Re: File No: CDR23-002, ED23-062, TS23-001 (PLAN23-081)

Development Application for Dominican Valley Housing Development including Conceptual Design Review, Environmental and Design Review, and Tentative Subdivision Map Application (APN 015-163-03)

Pursuant to Government Code section 65943 et seq., this letter informs you that the above referenced application is INCOMPLETE. The elements needed to make the application complete are detailed in the following sections of this letter. To facilitate the development review process, please include a detailed response letter with your resubmittal that addresses all items contained in this letter. Similarly, please provide written responses to the items identified as incomplete by other reviewers.

SUBJECT: Planning File #PLAN23-081 – Design Review Application: 50 Units Dominican Site

BOUNDARY & TOPOGRAPHIC SURVEY
DOMINICAN PARCEL A.P.N. (015-163-03)
MARIN COUNTY
CITY OF SAN RAFAEL

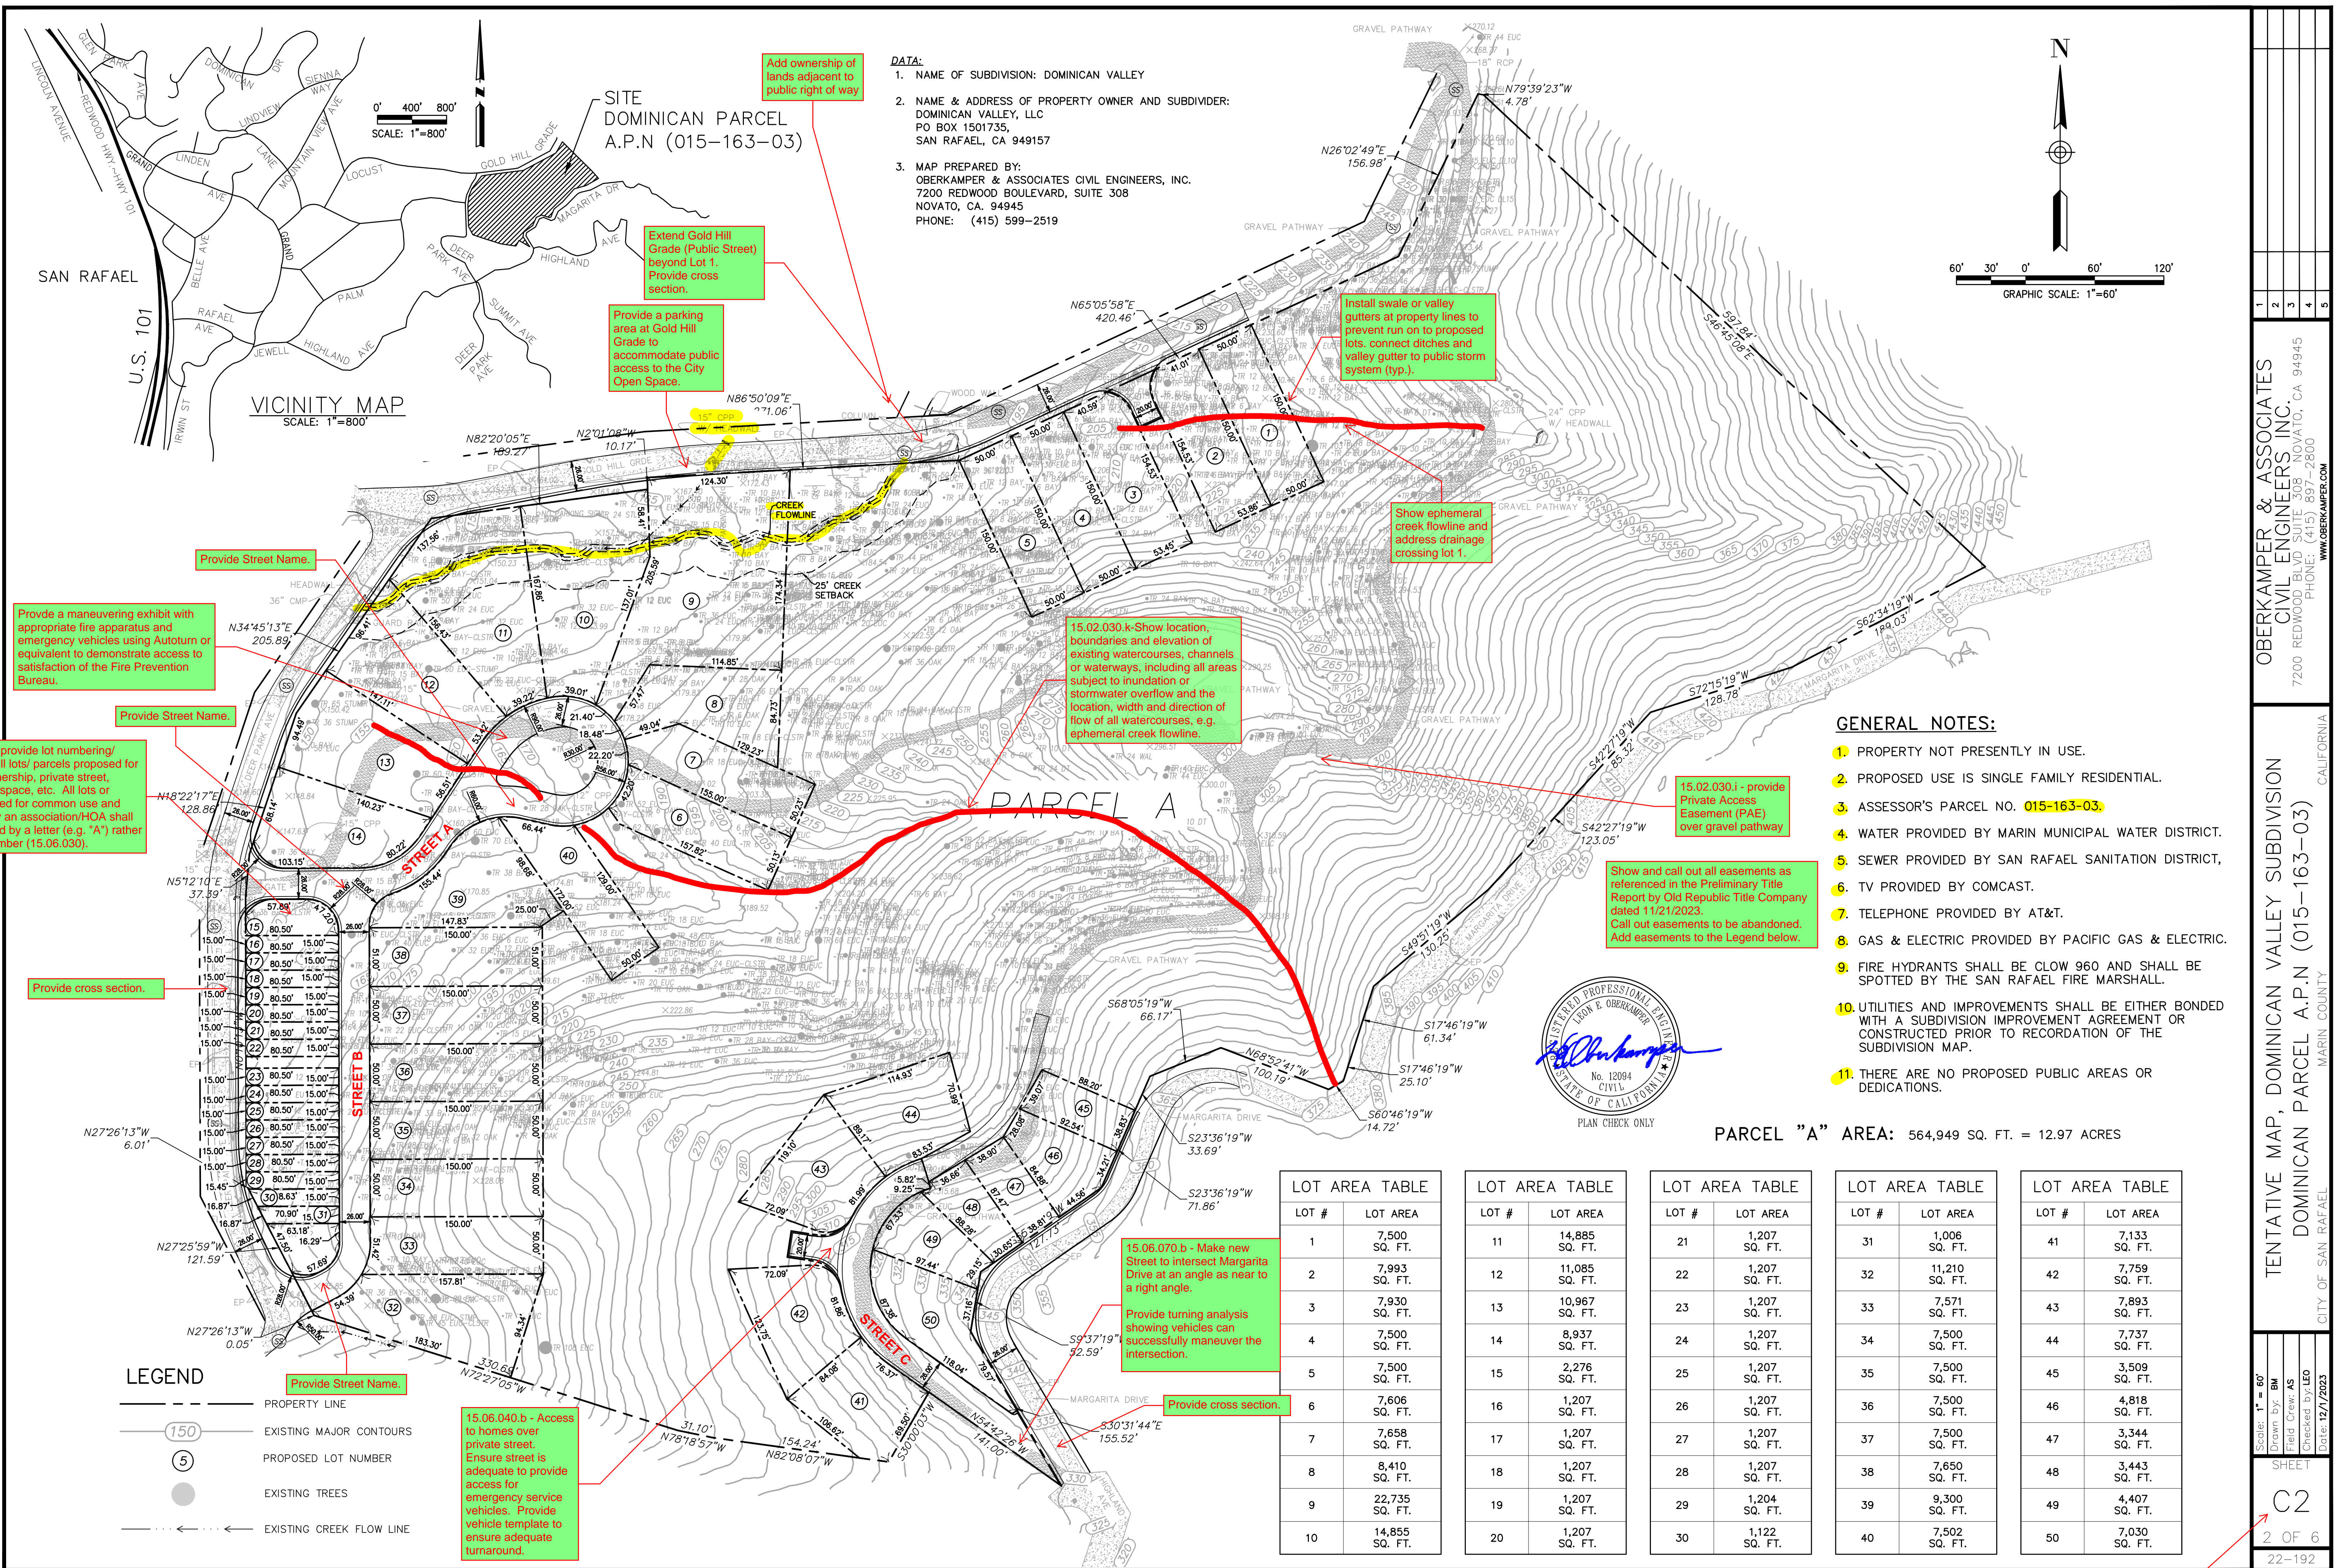
18. Sheet C1 (Boundary & Topographic Survey)- Show and call out easements referenced in the Preliminary Title Report by Old Republic Title Company dated 11/21/2023. Call out easements to be abandoned. Add easement lines to the legend.

Provide sheet Index

15.07.020.e.5 - Provide Erosion Control plan

Show and call out all easements as referenced in the Preliminary Title Report by Old Republic Title Company dated 11/21/2023. Call out easements to be abandoned. Add easements to the Legend below.

Scale: 1" = 80'
Drawn by: BM
Field Crew: AS
Checked by: LEO
Date: 12/1/2023
SHEET C2
2 OF 6
22-192

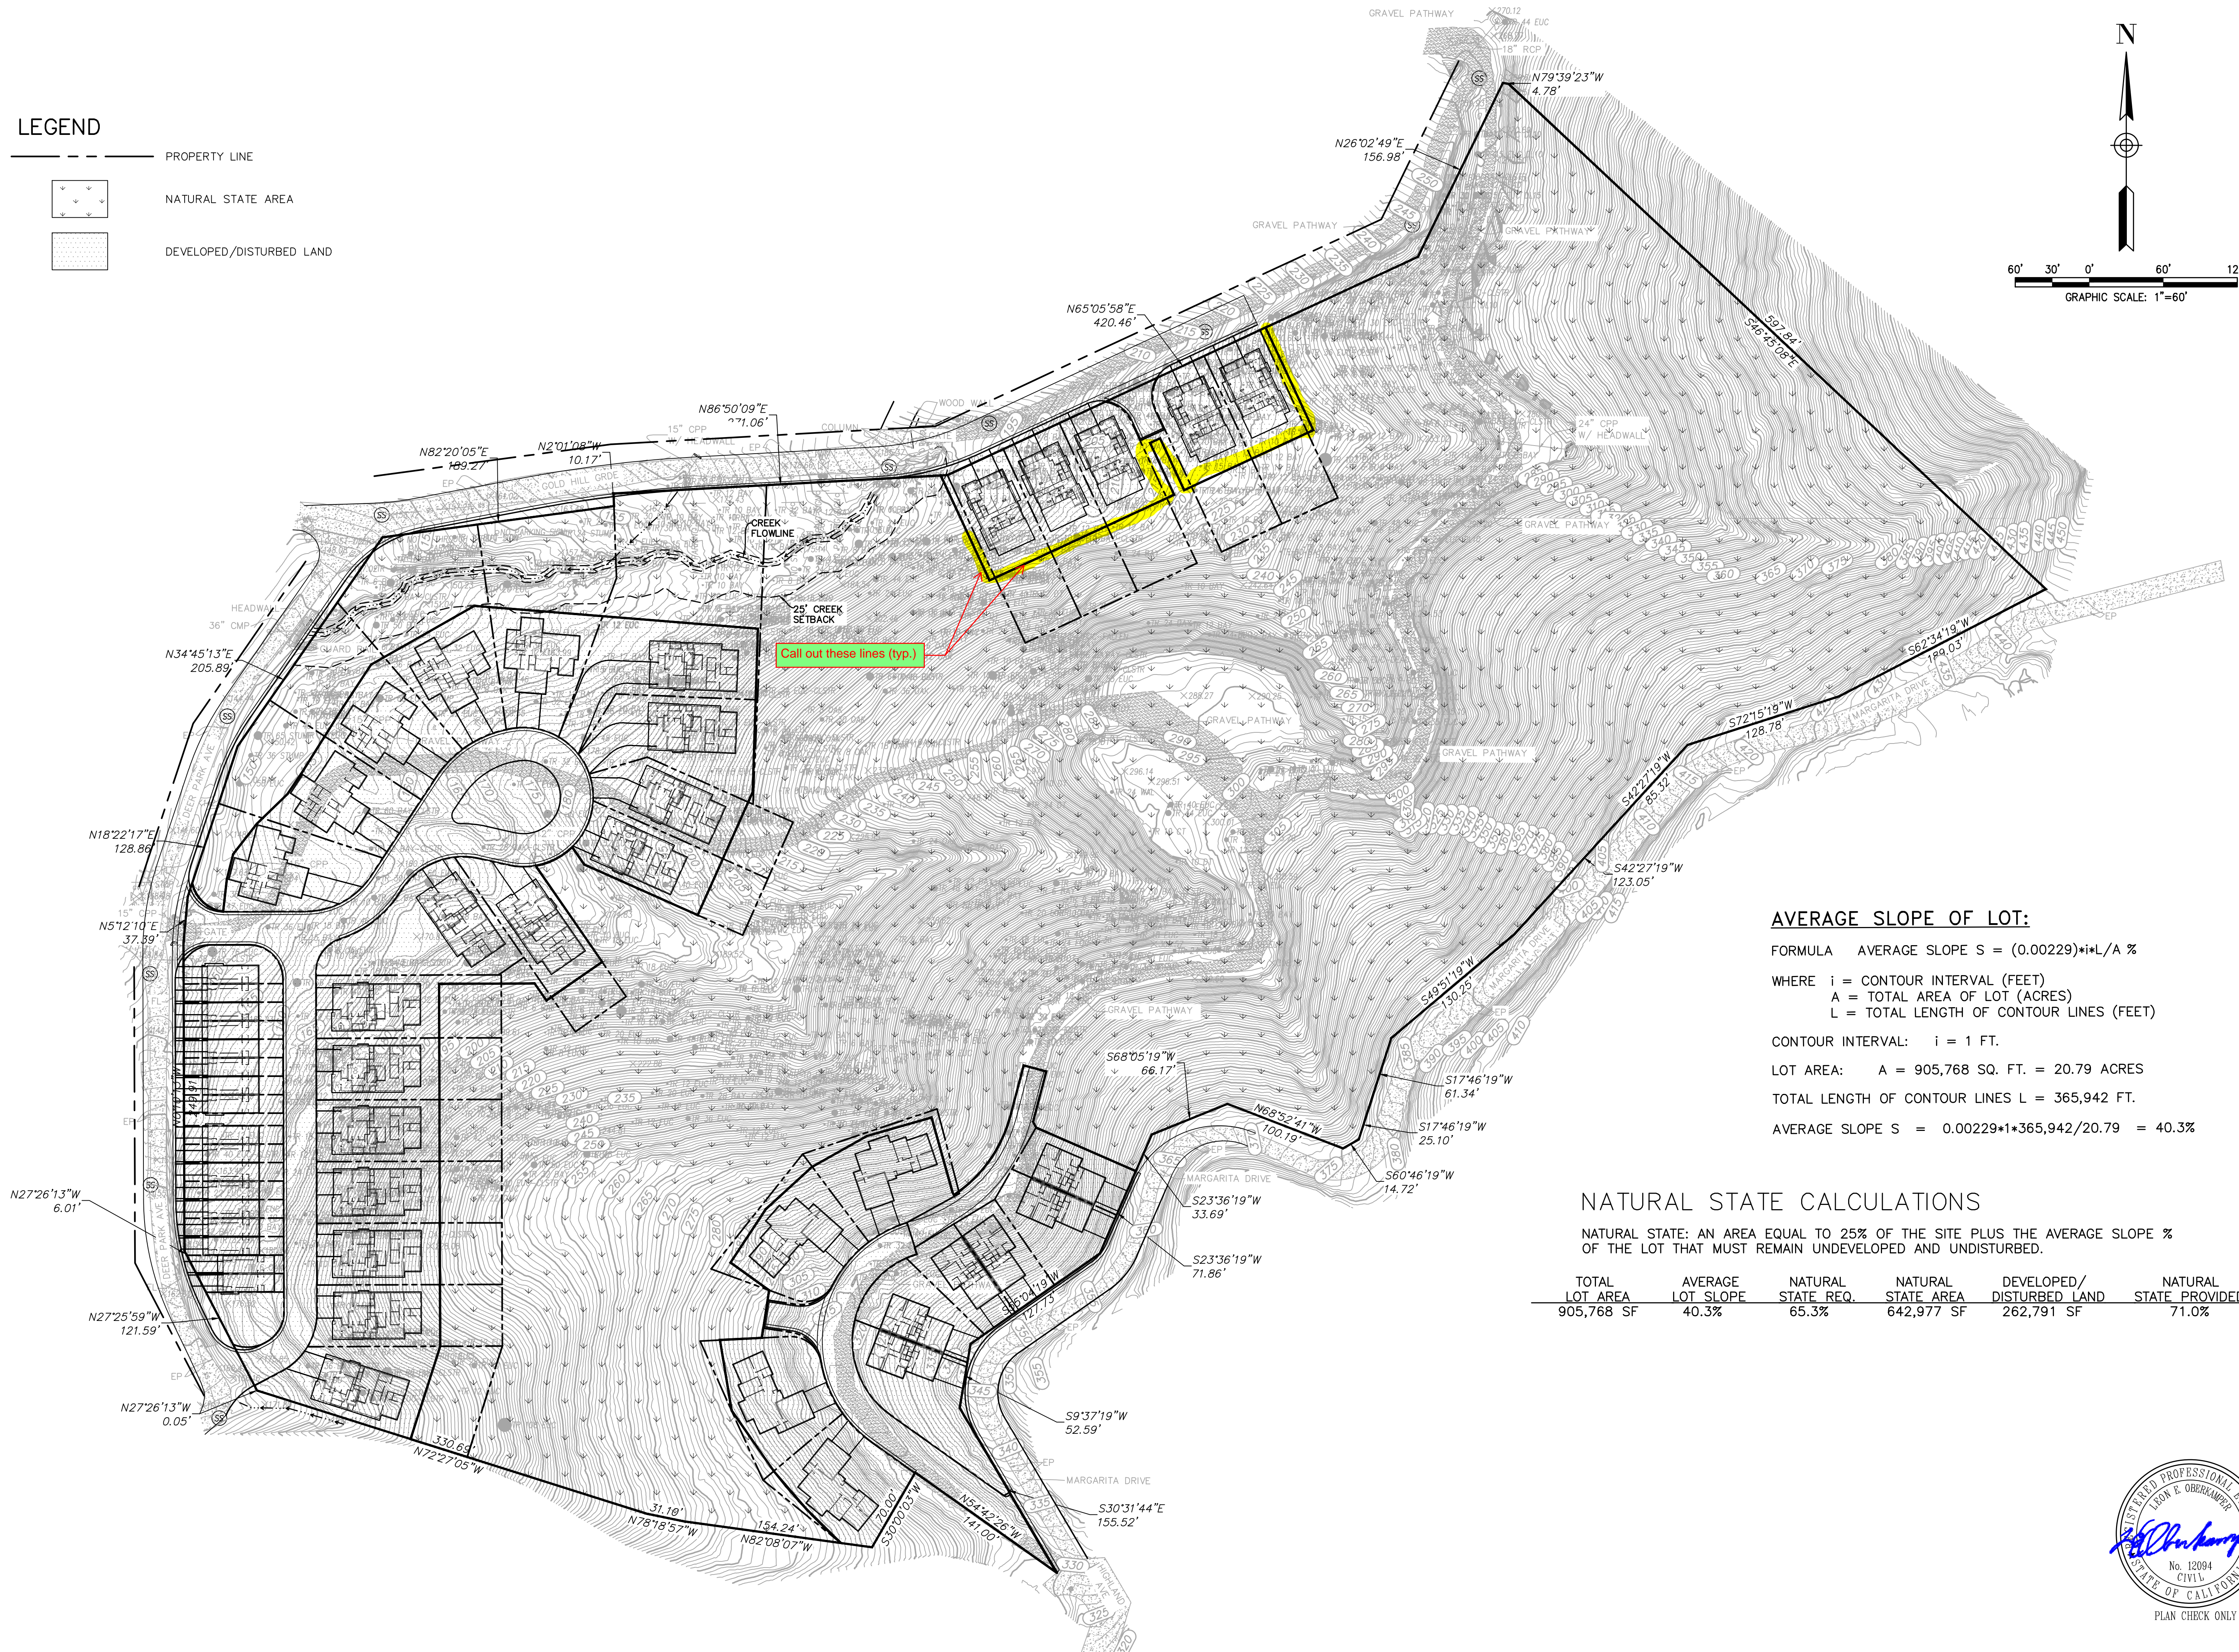
19. Sheet C2 (Tentative Map)- Use Sheet C2 as the sheet title sheet and change the sheet number to C1. Include pertinent information from S.R.M.C. sections 15.02.030 and 15.02.040. Change Boundary & Topographic Survey sheet to C2.

15.02.030.j - provide lot numbering/lettering for all lots/parcels proposed for common ownership, private street, private open space, etc. All lots or parcels created for common use and ownership by an association/HOA shall be designated by a letter (e.g. "A") rather than a lot number (15.06.030).

Provide Street Name.

Provide a maneuvering exhibit with appropriate fire apparatus and emergency vehicles using Autoturn or equivalent to demonstrate access to satisfaction of the Fire Prevention Bureau.

Provide cross section.

15.06.040.b - Access to homes over private street. Ensure street is adequate to provide access for emergency service vehicles. Provide vehicle template to ensure adequate turnaround.

Add ownership of lands adjacent to public right of way.

Extend Gold Hill Grade (Public Street) beyond Lot 1. Provide cross section.

Provide a parking area at Gold Hill Grade to accommodate public access to the City Open Space.

15.02.030.k - Show location, boundaries and elevation of existing watercourses, channels or waterways, including all areas subject to inundation or stormwater overflow and the location, width and direction of flow of all watercourses, e.g. ephemeral creek flowline.

Show ephemeral creek flowline and address drainage crossing lot 1.

15.02.030.i - provide Private Access Easement (PAE) over gravel pathway

Show and call out all easements as referenced in the Preliminary Title Report by Old Republic Title Company dated 11/21/2023. Call out easements to be abandoned. Add easements to the Legend below.

15.06.070.b - Make new Street to intersect Margarita Drive at an angle as near to a right angle. Provide turning analysis showing vehicles can successfully maneuver the intersection.

Make Sheet C2 Title Sheet for the Tentative Map.
